# Access Compliance Report

## Public Rights-of-Way

### (Curb Ramps)

Intersection ID: 13925	Main Street: BERKELEY_AV	Cross Street: EUCLID_AV	Location: S
ADA ID: B1CD36F94083	Ramp Type: PerpDiag	Initial Pass/Fail: Fail	Overall Compliance: No
Severity Score: 26.25			
Codes/Mitigation Info/Possible Solution		Field Measurements/Component Compliance

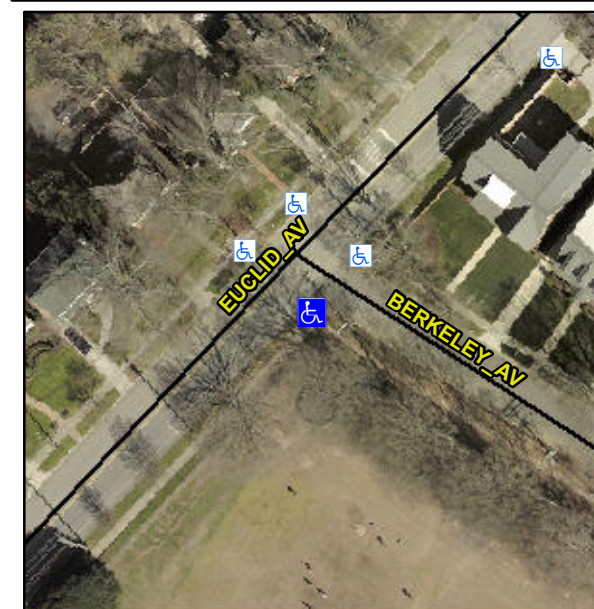
**Not Found, R304.2.2, R304.5.3**

Compliance	Description	Data	Compliance	Description	Data
N/A	Ramp Length (in)	72.0	No	Ramp Slope (%)	14.8
Yes	Ramp Width (in)	48.0	No	Ramp XSlope (%)	4.8
N/A	Flare Type LT	N/A	N/A	Flare Type RT	N/A
N/A	Flare Slope LT (%)	N/A	N/A	Flare Slope RT (%)	N/A
N/A	Flare Traversable LT?	N/A	N/A	Flare Traversable RT?	N/A
N/A	Landing Length (in)	N/A	N/A	DWS Provided?	N/A
N/A	Landing Width (in)	N/A	N/A	DWS Contrast?	N/A
N/A	Landing Slope (%)	N/A	N/A	DWS Length (in)	N/A
N/A	Landing X Slope (%)	N/A	N/A	DWS Full Width?	N/A
N/A	Landing Curb? (Y/N)	N/A	N/A	DWS Offset (in)	N/A
N/A	Shared Landing?	N/A			
N/A	Gutter Ponding?	Yes	N/A	Gutter Slope (%)	N/A
N/A	Gutter Lip Ht (in)	N/A	N/A	Gutter X Slope (%)	N/A
N/A	Painted X Walk1?	No	N/A	Painted X Walk2?	No
	X Walk 1 Direction	To NE		X Walk 2 Direction	To NW
N/A	X Walk 1 Width (in)	N/A	N/A	X Walk 2 Width (in)	N/A
	X Walk 1 Slope (%)	1.2		X Walk 2 Slope (%)	7.9
	X Walk 1 X Slope (%)	4.8		X Walk 2 X Slope (%)	2.4

**Remove & Replace Curb Ramp With Two New Directional Ramps or Equivalent.**
